TOWN OF GRAFTON, VT CAMBRIDGEPORT BRIDGE

PROPOSED IMPROVEMENT BRIDGE PROJECT COUNTY OF WINDHAM VT ROUTE 121, BRIDGE NO. 16G

RECORD PLANS	
CONTRACTOR:	F.W. WHITCOMB CONSTRUCTION CORP. - WALPOLE, NH
RESIDENT ENGINEER:	CHAD GREENWOOD
CONSTRUCTION BEGAN:	APRIL 11, 2006
CONSTRUCTION COMPLETE:	MAY 11, 2007
RECORD PLANS BY:	CHAD GREENWOOD & AMOS KEMPTON
I HEREBY CERTIFY THAT ALL THE CONSTRUCTION REQUIRED BY THIS SET OF DRAWINGS HAS BEEN ACCOMPLISHED AS INDICATED HEREIN.	
BY:	RESIDENT ENGINEER
DATE:	1/23/12
NOTE: Any further information concerning final quantities, amounts or other details relative to this project may be found at Central Files in the electronic archives.

THIS SHEET SUPERSEDES CONTRACT PLAN SHEET 1 DATED 6/05. REVISIONS ON THIS SHEET REFLECT CHANGES IN DESIGN AND DETAILS AS PER CHANGE ORDER NO. 2, SUBSTITUTING NEW STEEL BEAMS FOR RECYCLED BEAMS.

BEAM ELEVATION
NOT TO SCALE

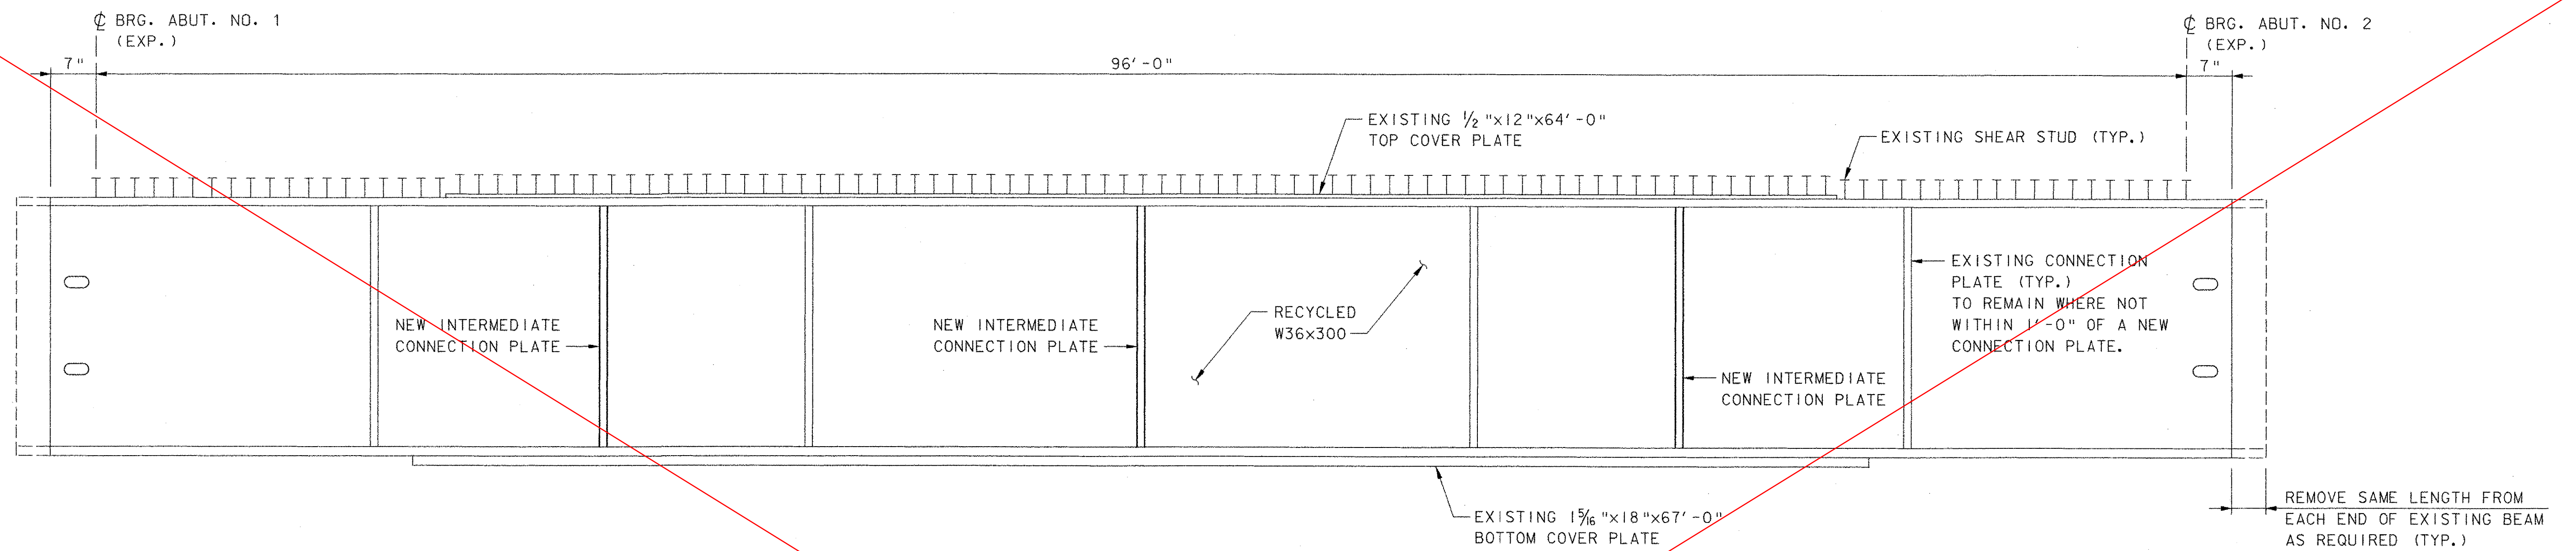
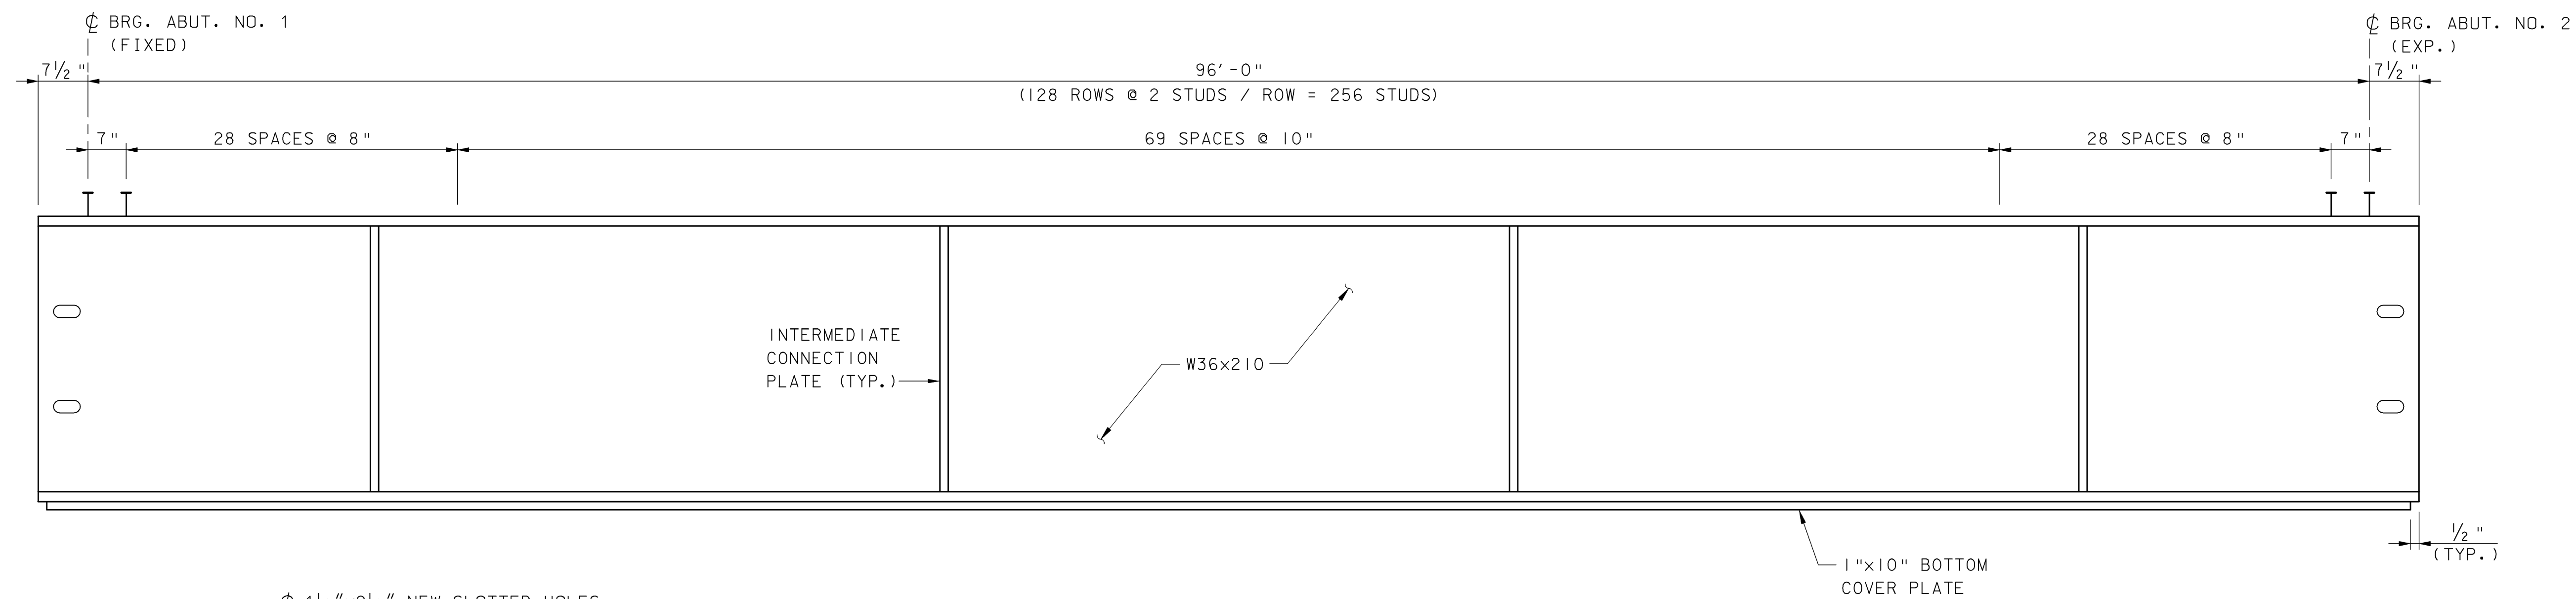
1. THE BEAMS FOR THIS PROJECT ARE "RECYCLED". SEE STRUCTURAL STEEL NOTES ON SHEET 26 AND SPECIAL PROVISIONS.
2. THE INFORMATION REGARDING THE BEAMS IS TAKEN FROM ORIGINAL PLANS. SEE GENERAL NOTE NO. 4 AND 6 ON SHEET 26.
3. ANY ONE LINE OF DIAPHRAGMS MAY BE SHIFTED BY UP TO TWO FEET IF THAT SHIFT WILL ELIMINATE THE NEED TO REMOVE EXISTING CONNECTION PLATES.
4. ACTUAL CAMBER OF THE BEAMS TO BE REUSED IS UNKNOWN.

THIS SHEET SUPERSEDES CONTRACT PLAN SHEET 31 DATED 6/05. REVISIONS ON THIS SHEET REFLECT CHANGES IN DESIGN AND DETAILS AS PER CHANGE ORDER NO. 2. SUBSTITUTING NEW STEEL BEAMS FOR RECYCLED BEAMS.

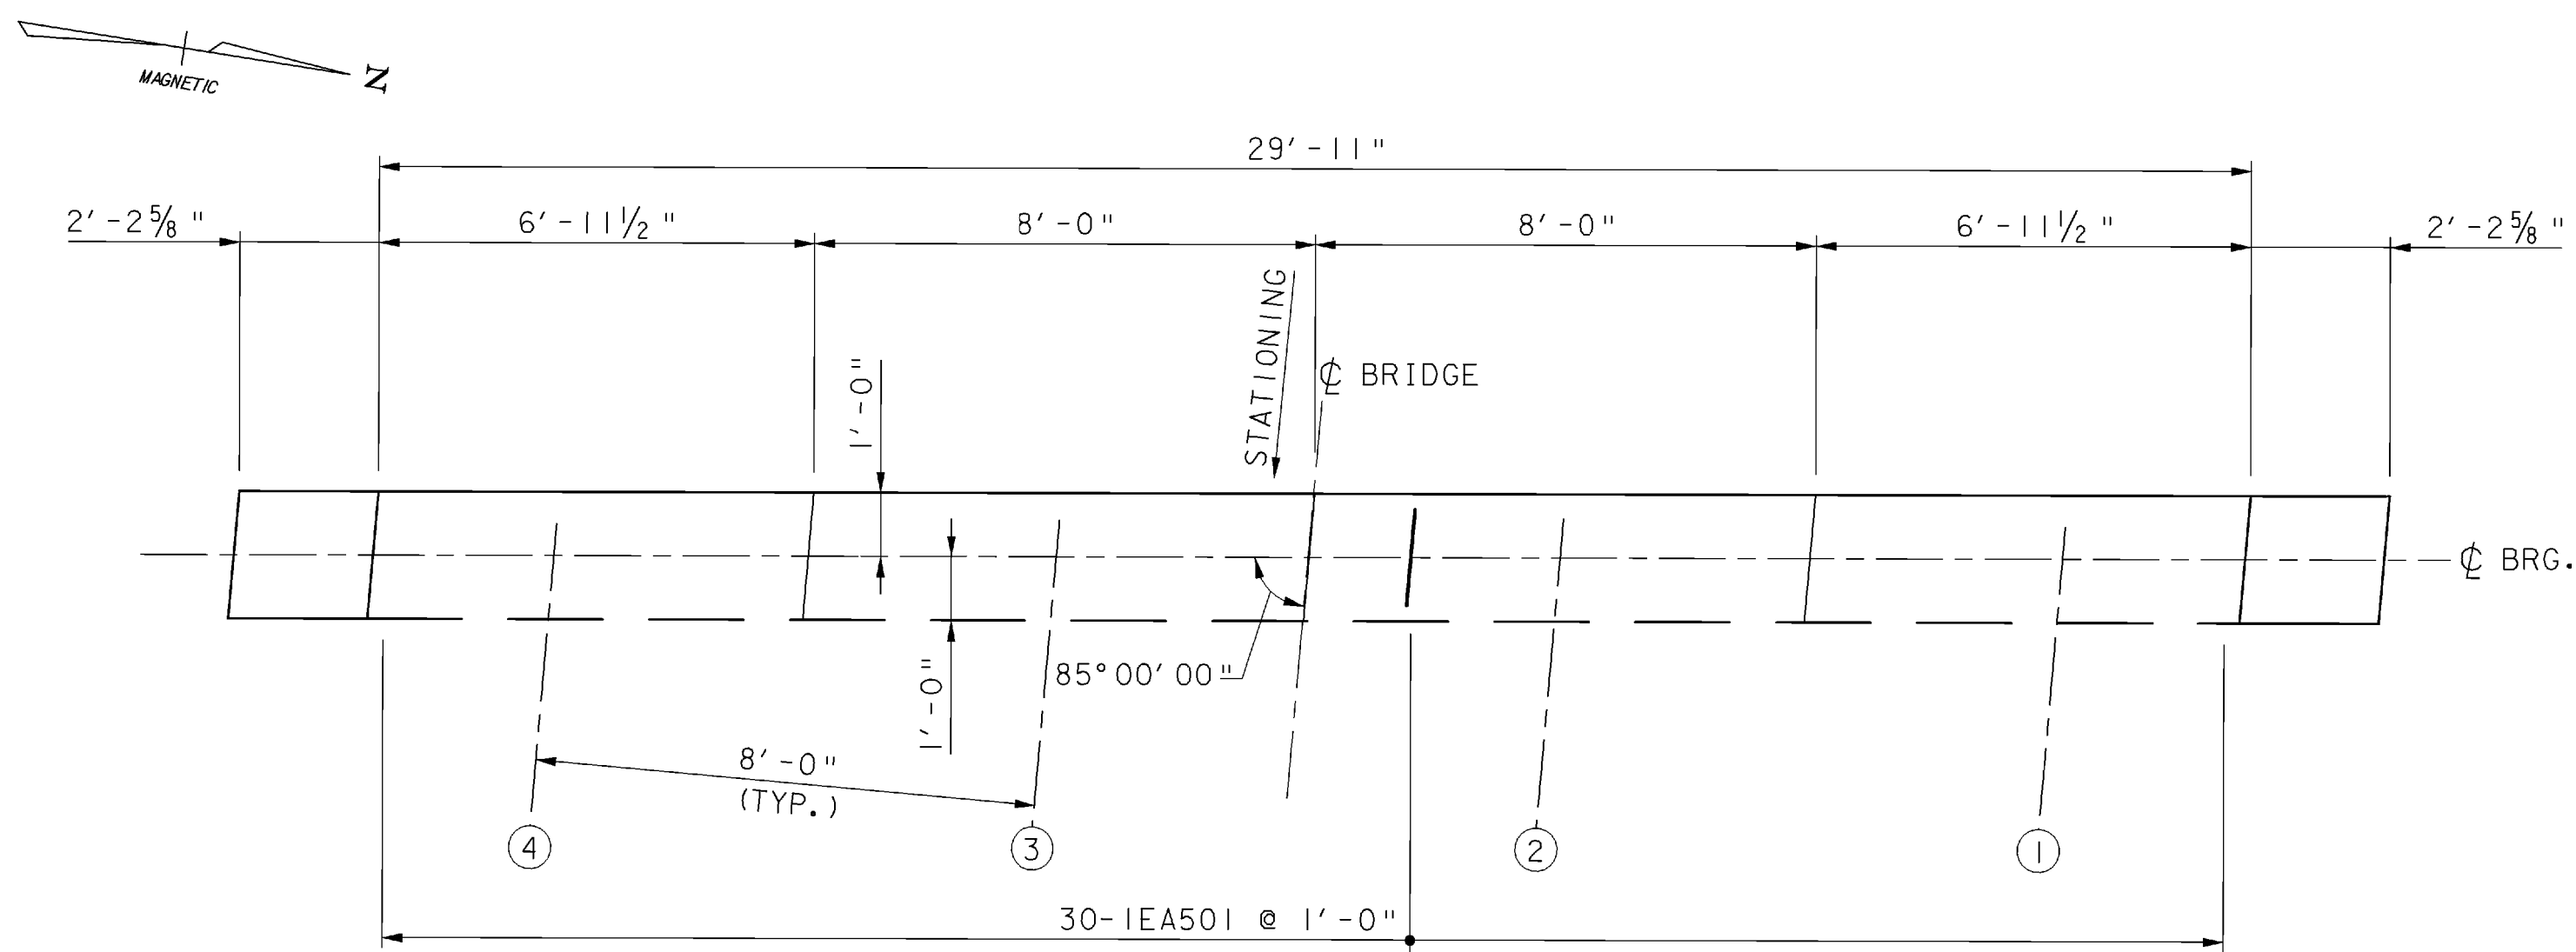
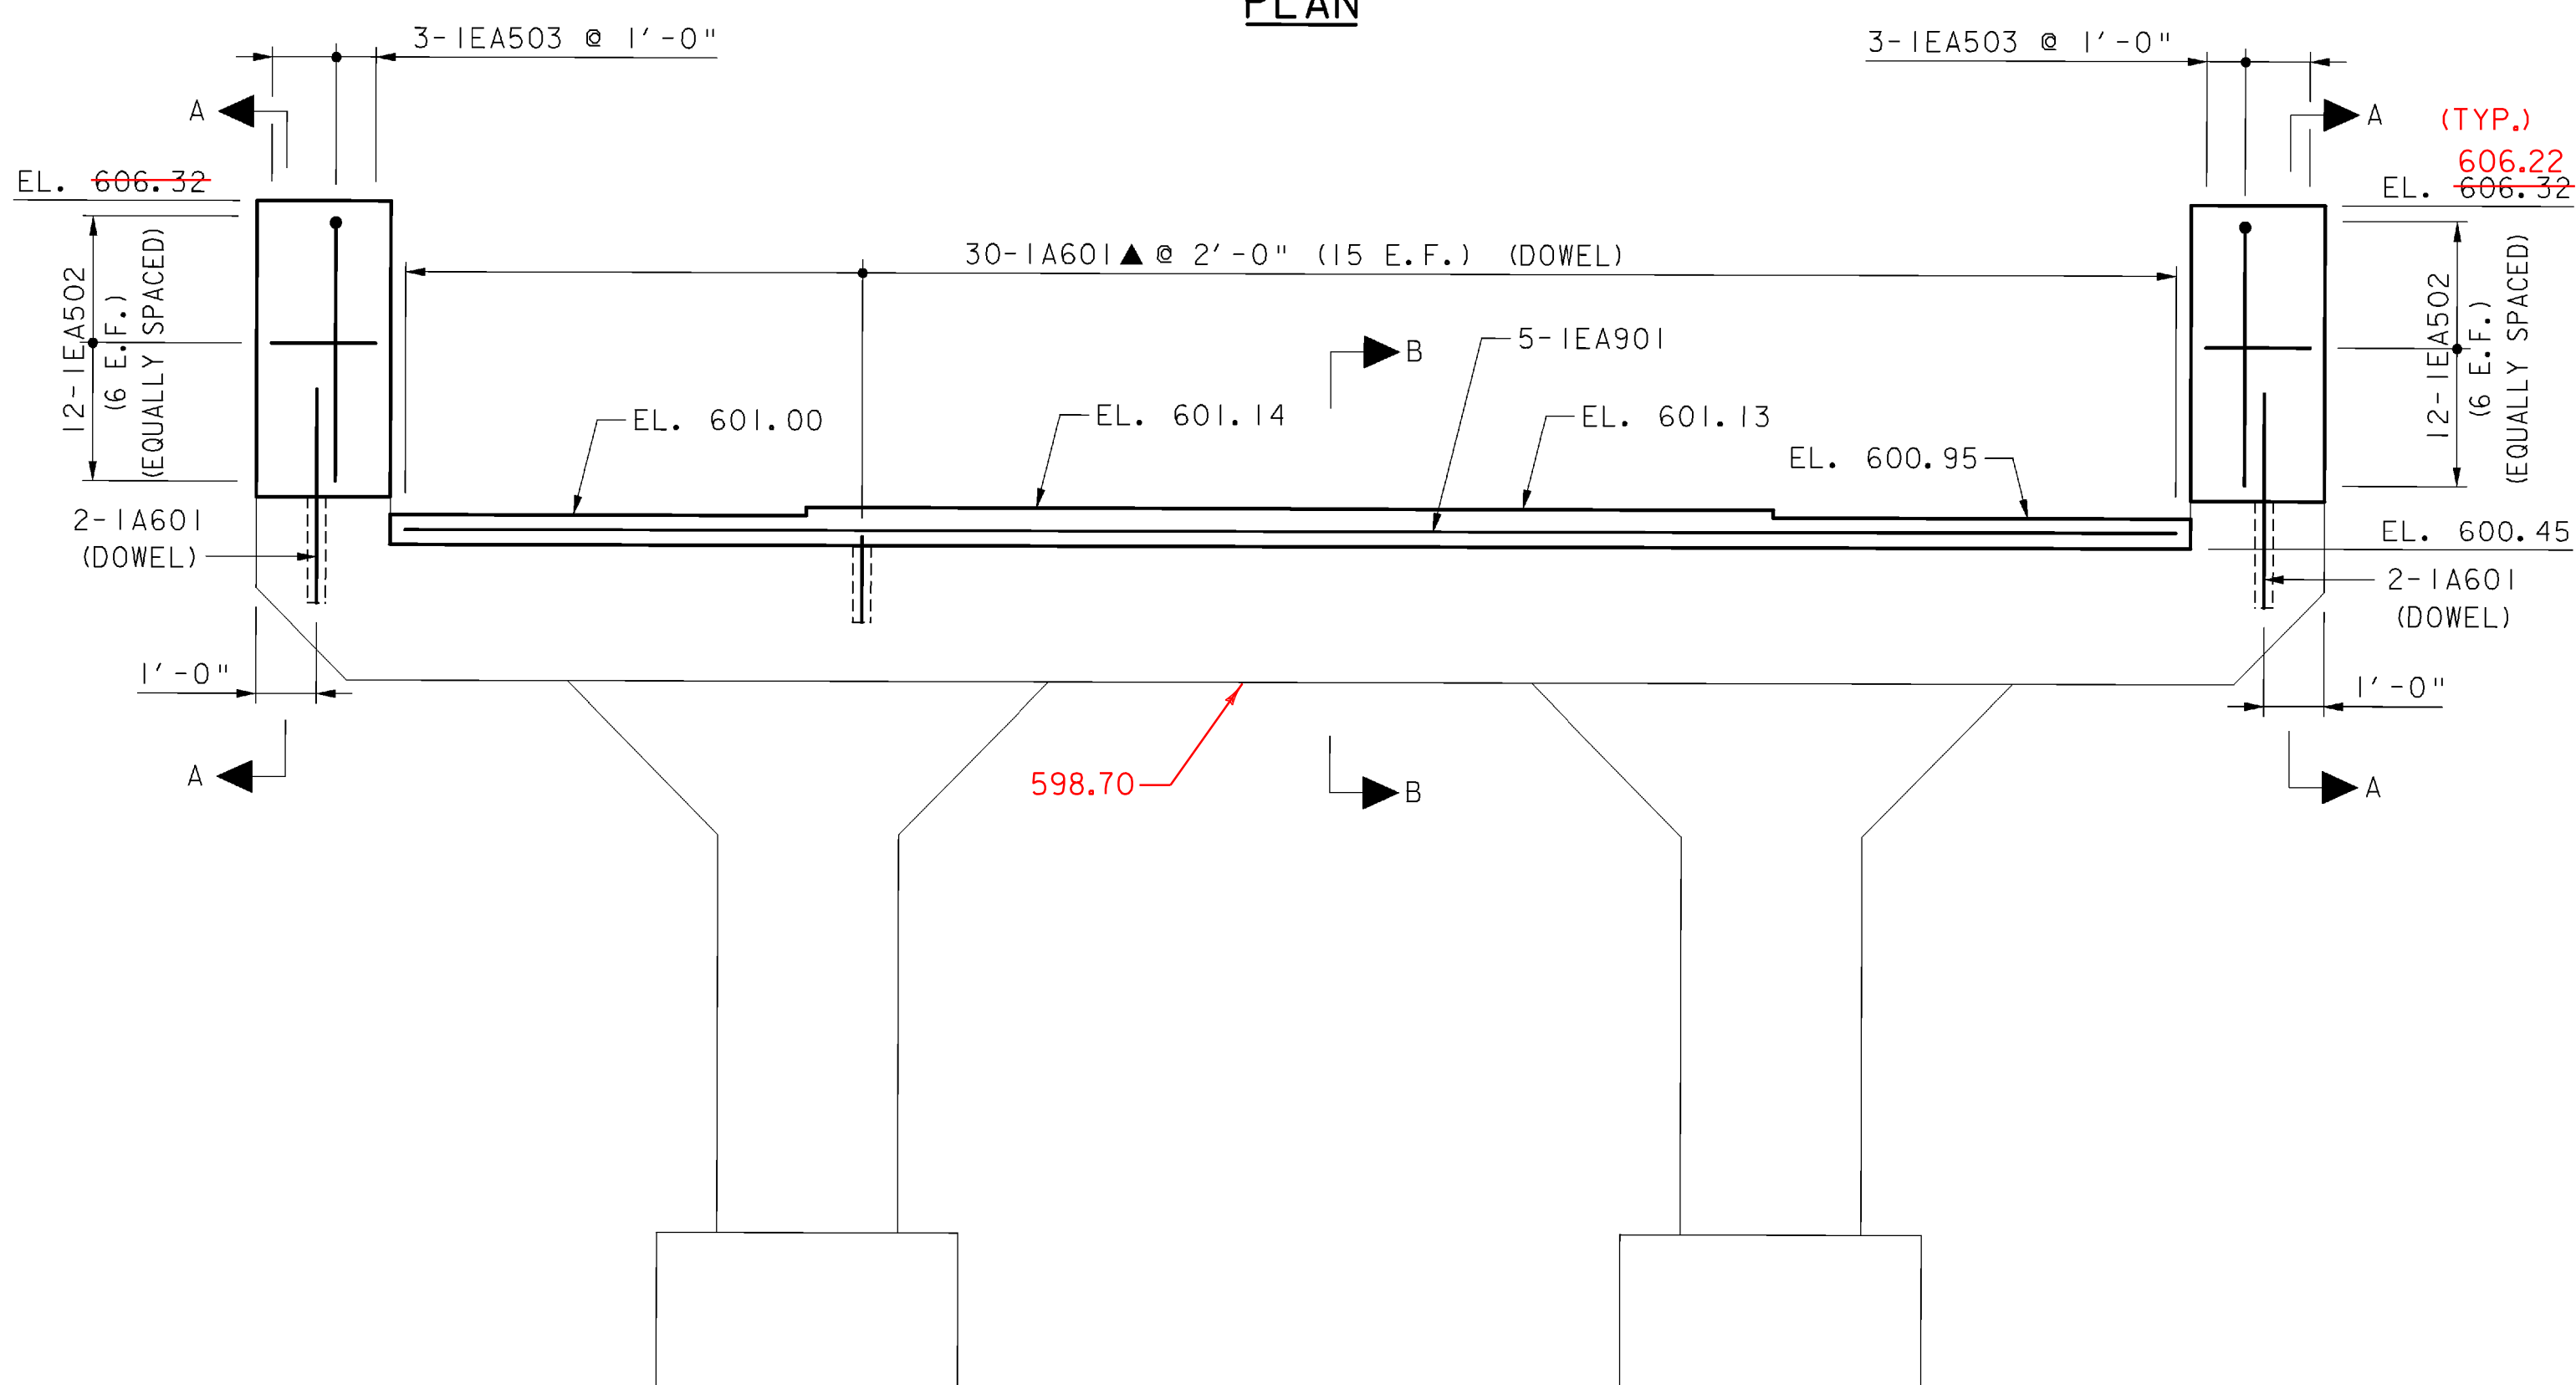
THIS SHEET SUPERSEDES CONTRACT PLAN SHEET 35 DATED 6/05. REVISIONS ON THIS SHEET REFLECT CHANGES IN DESIGN AND DETAILS AS PER CHANGE ORDER NO. 2, SUBSTITUTING NEW STEEL BEAMS FOR RECYCLED BEAMS.
